April 21, 2014

**Subject: 421 Warren Avenue  
Preliminary Level III Site Plan Application  
Response to Peer Review Comments**

Attachment – AutoTurn Figure

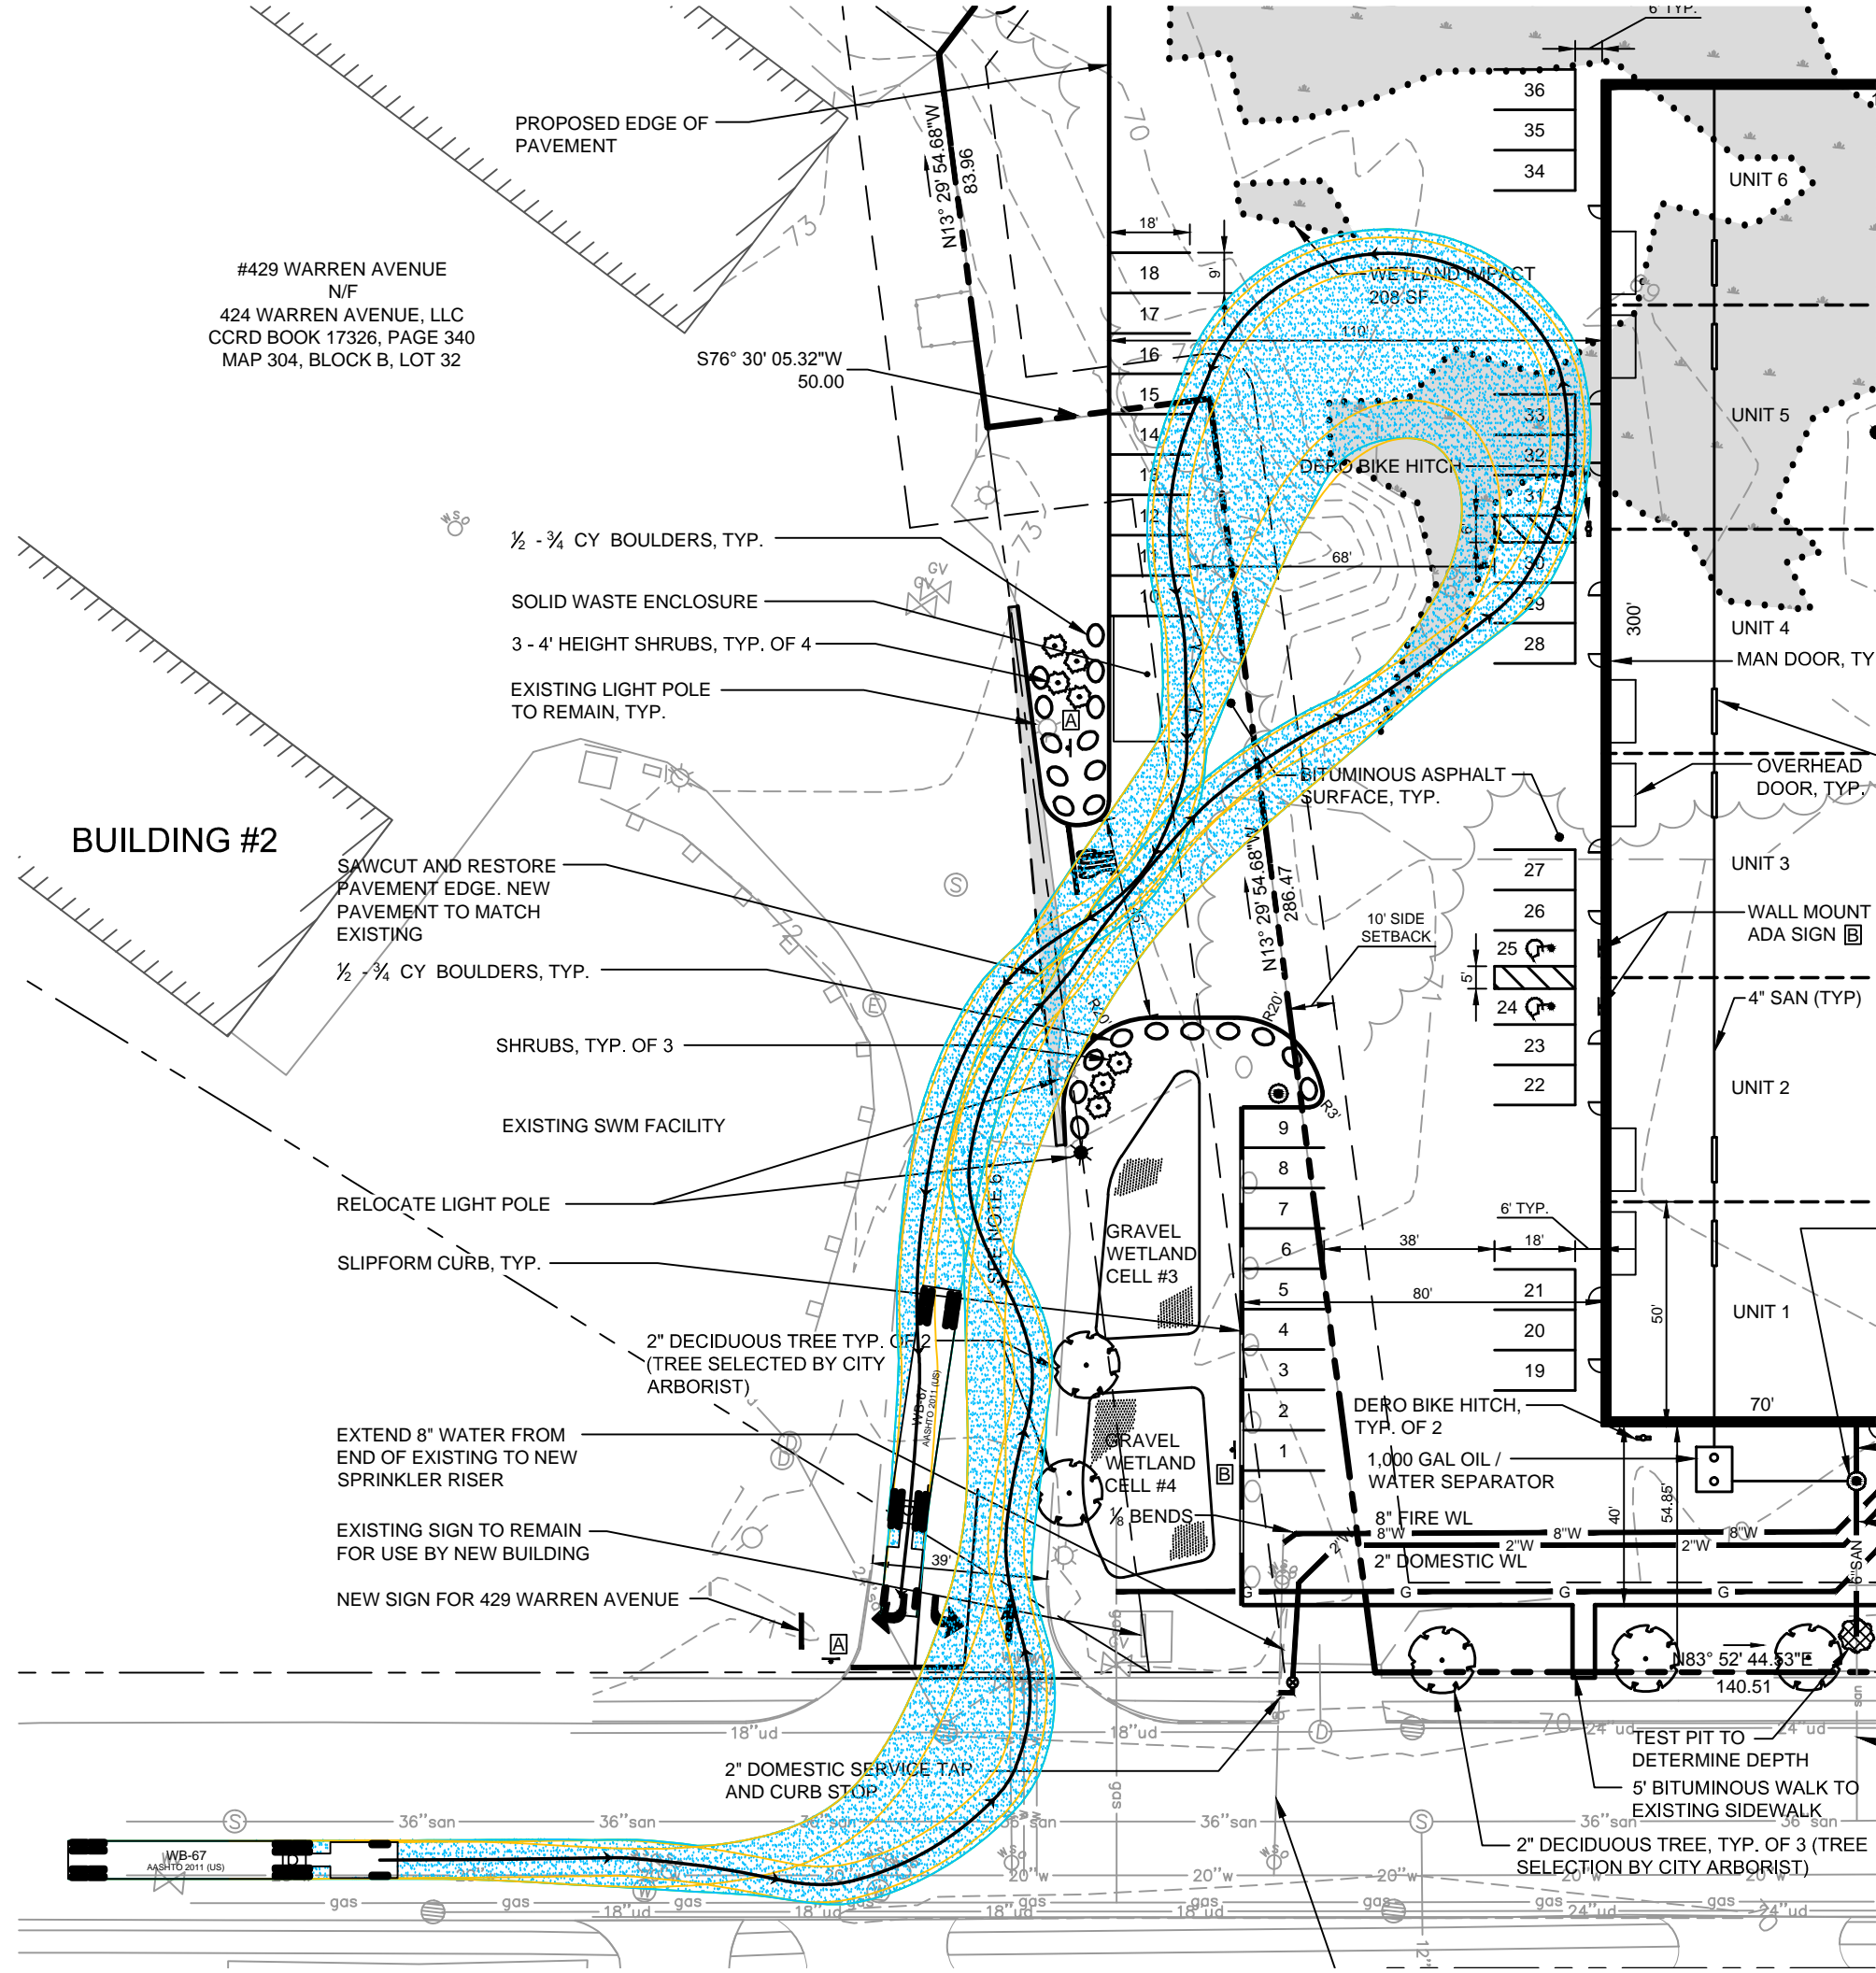
*The aisle widths in the internal parking/circulation area do not meet City standards and a waiver will be required. The applicant shall provide an Auto-Turn analysis documenting the need for the expanded pavement areas.*

See the accompanying Auto-Turn figure depicting the movement of a WB-67 vehicle into/out of the proposed yard area. The applicant is requesting a waiver of the parking area dimensional standards.
